CITY OF CONCORD
New Hampshire's Main Street™
Community Development Department
Planning Division

Staff Report for Planning Board

Project Summary – Major Site Plan and Architectural Design Review

Project: Urgent care clinic (2025-95)
Property Owner: Cafua Realty Trust CXXXIX, LLC
Applicant: Fulmer Lucas and Manchester Health Services, LLC
Property Address: 161 North State Street
Tax Map Lot: 583Z 30

C2.2

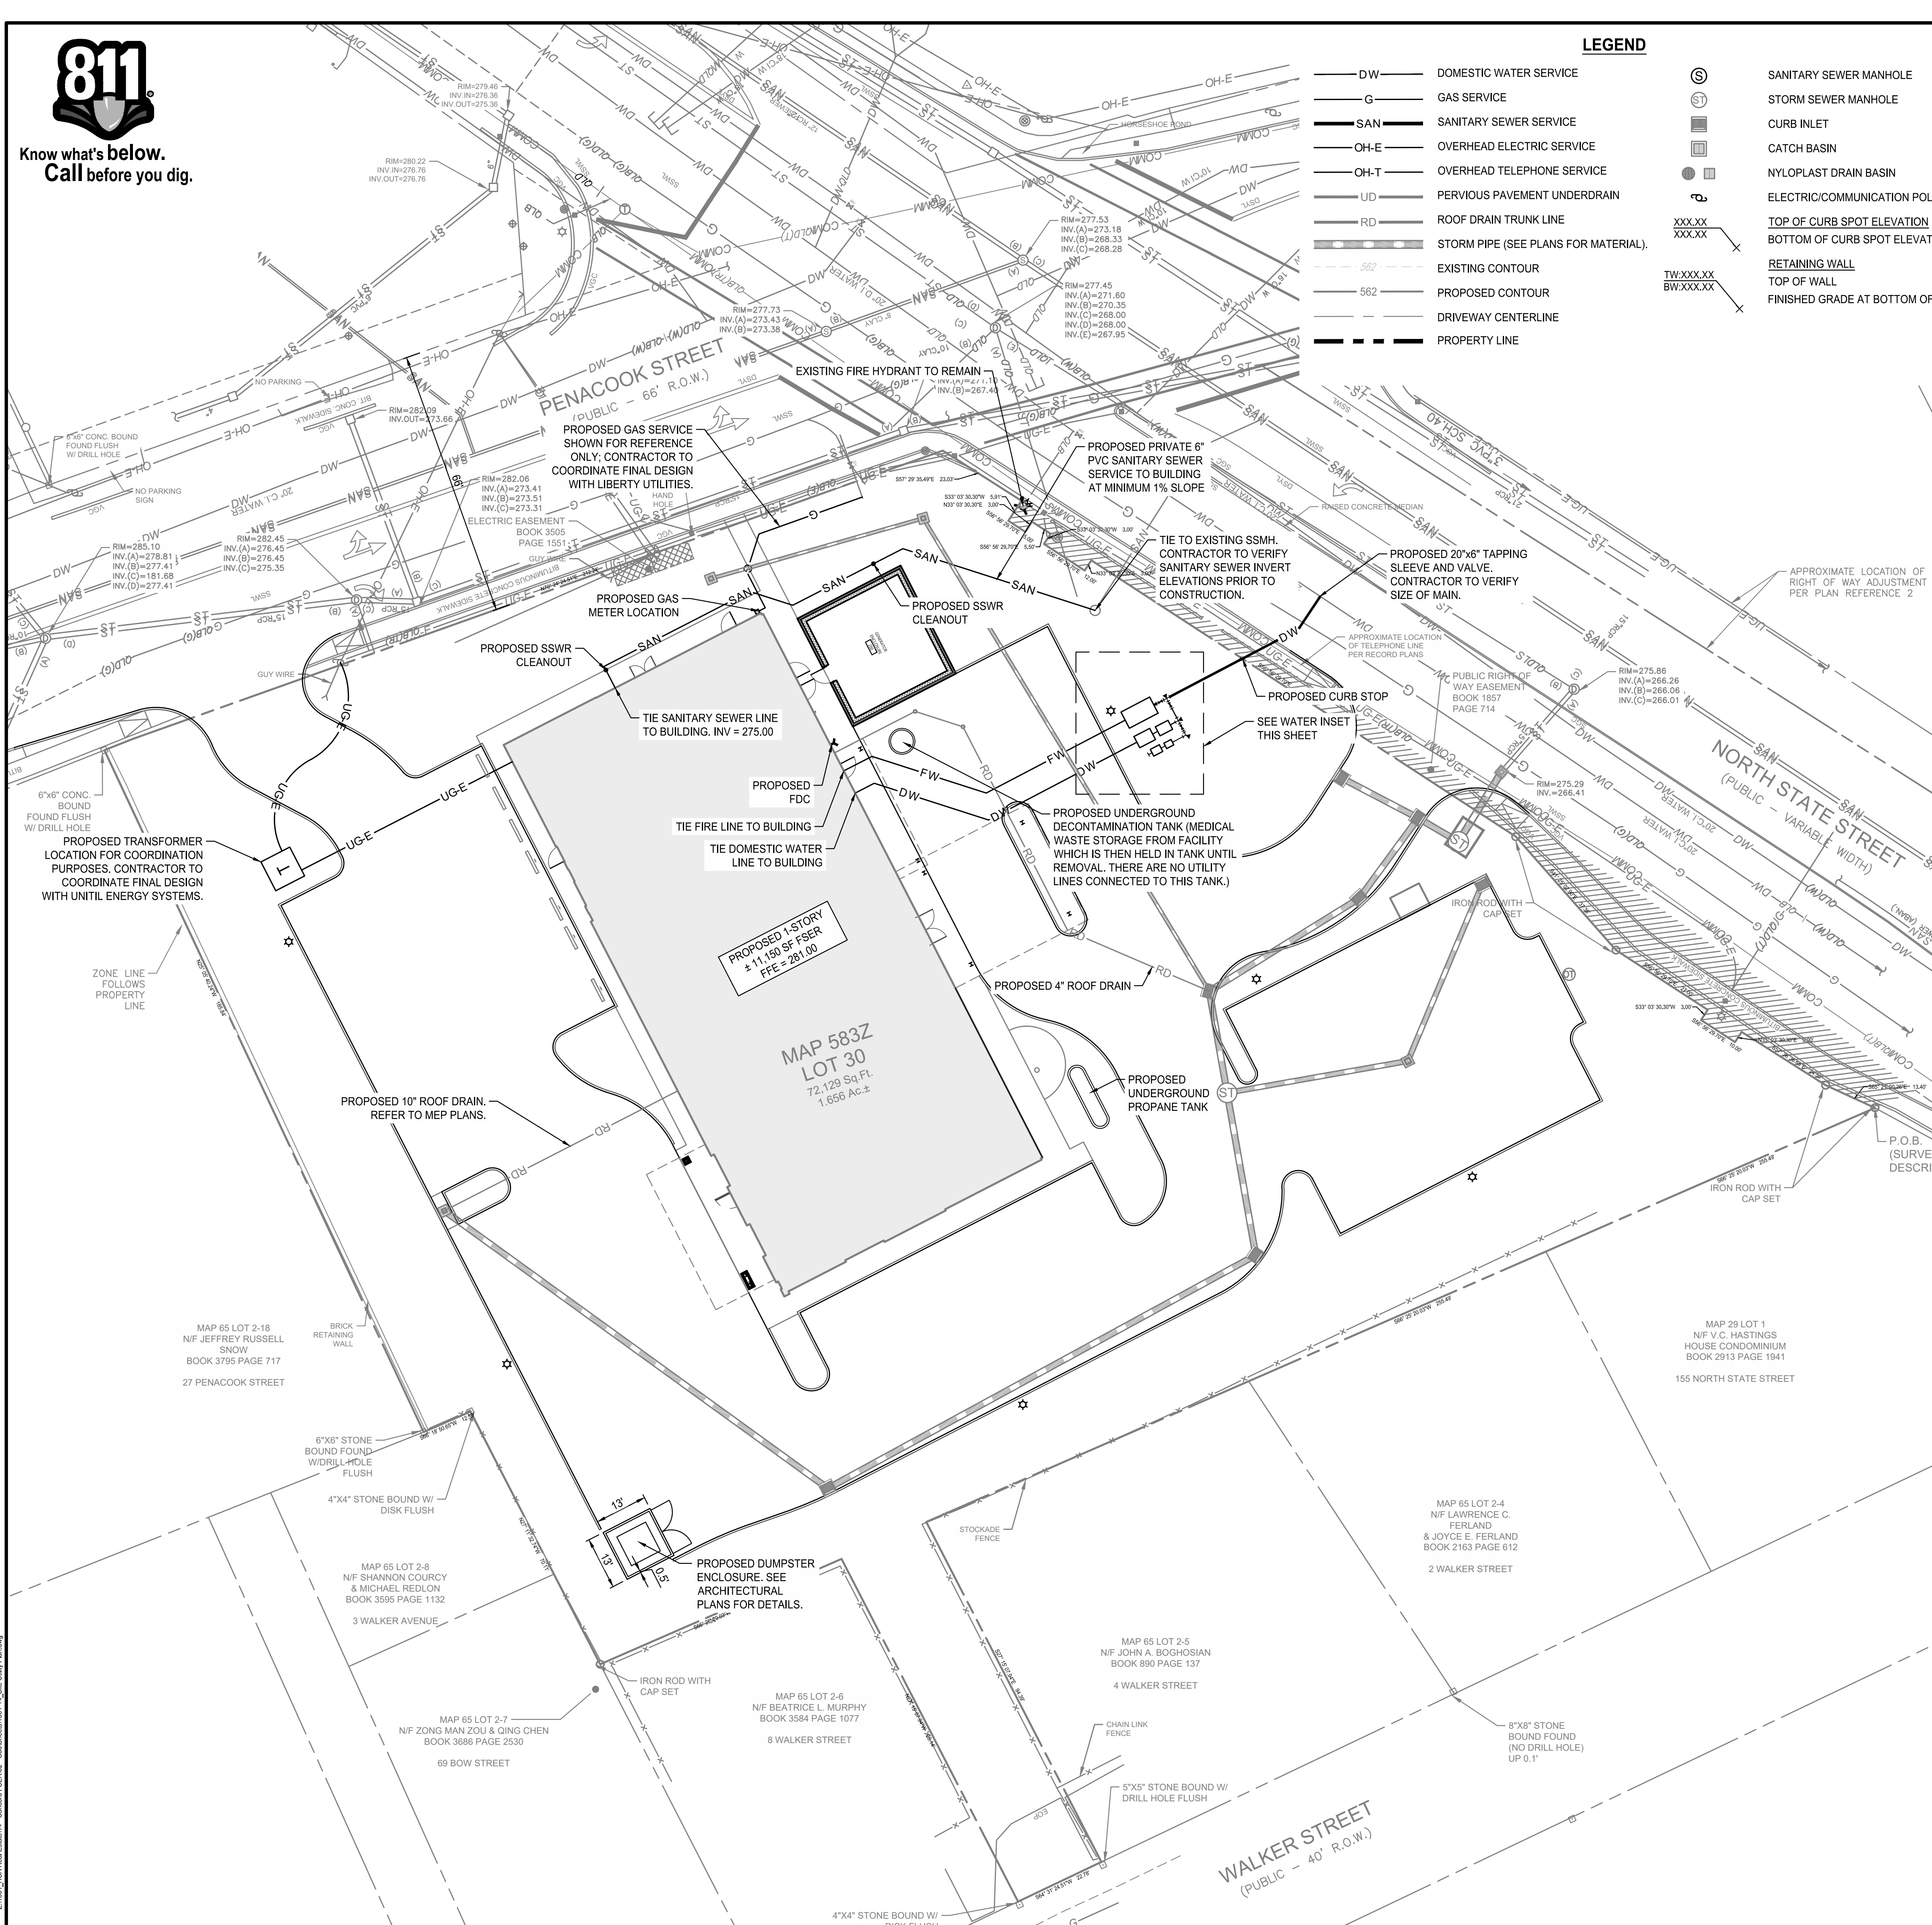
- a. Several storm lines appear to have less than 4' of cover on this sheet and Sheet C2.2. If 4' or more of cover cannot be achieved, 2" of rigid polystyrene thermal insulation with a minimum "R" value of 10 shall be required for a minimum of 8', pursuant to CCSD Section 6(3)(F)(2).

ACCESSIBLE PARKING SIGN
N.T.S.

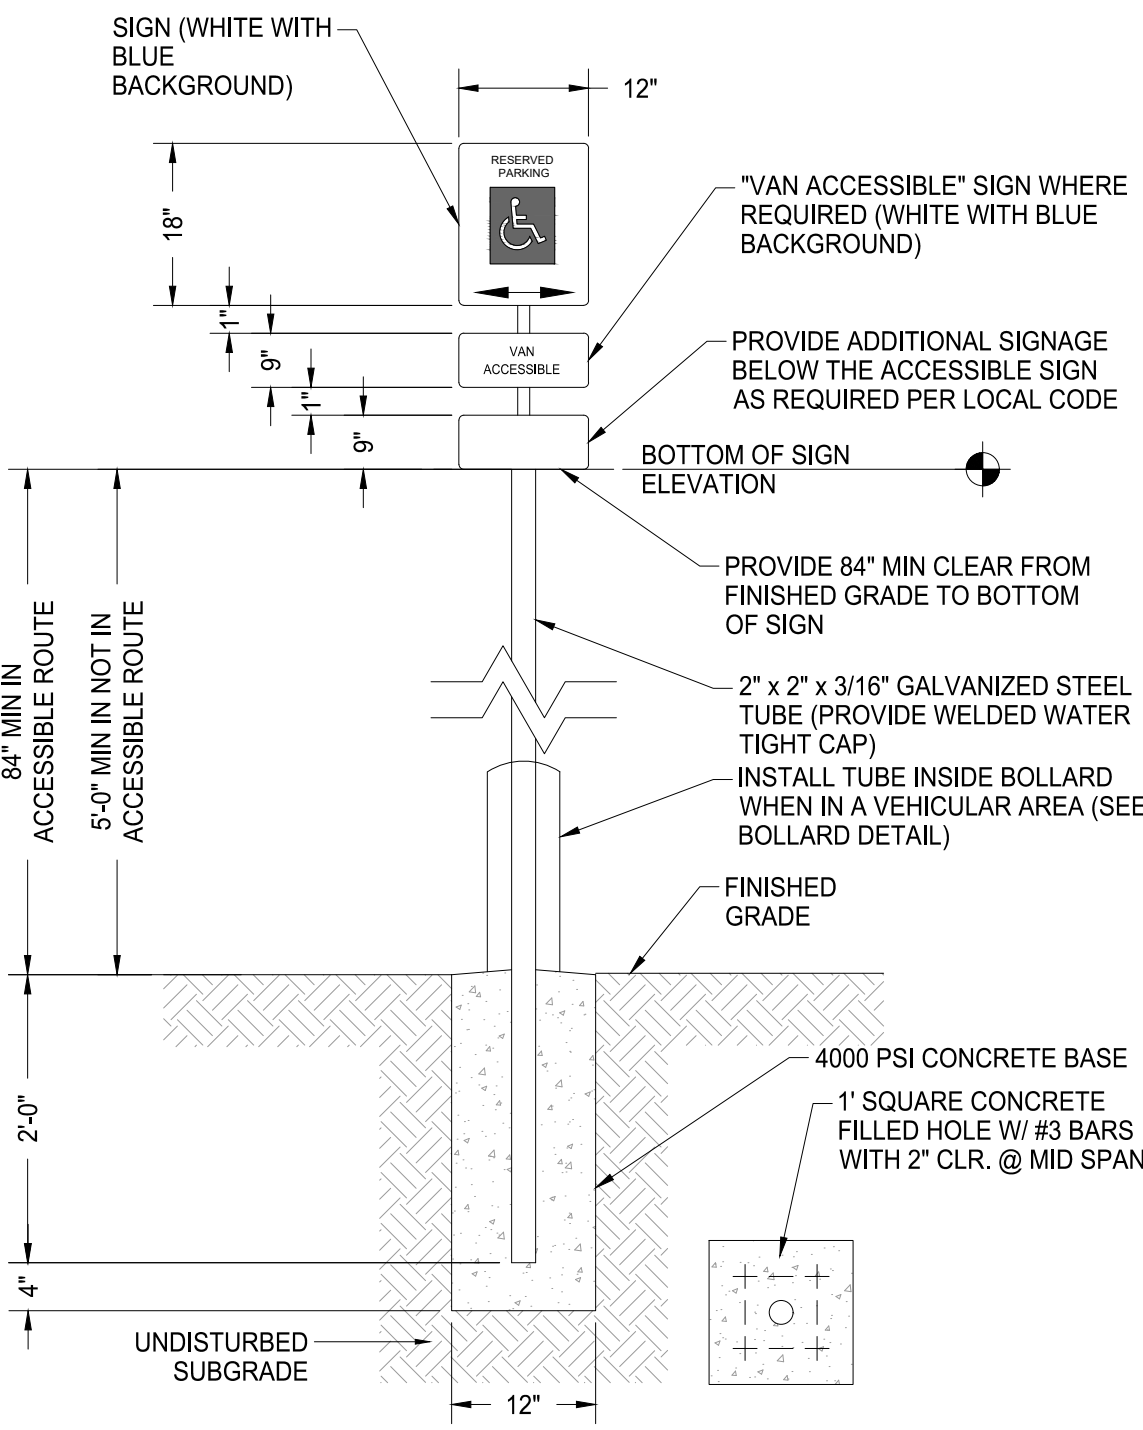
- c. In the Isolation Joint Detail, change the ½" joint to 5/16" to ¼" in width, pursuant to CCSD Section 3(3)(O)(4).
- d. In the Accessible Parking Sign Detail, revise the 6'-8" to 84", pursuant to CCSD Detail M-1.
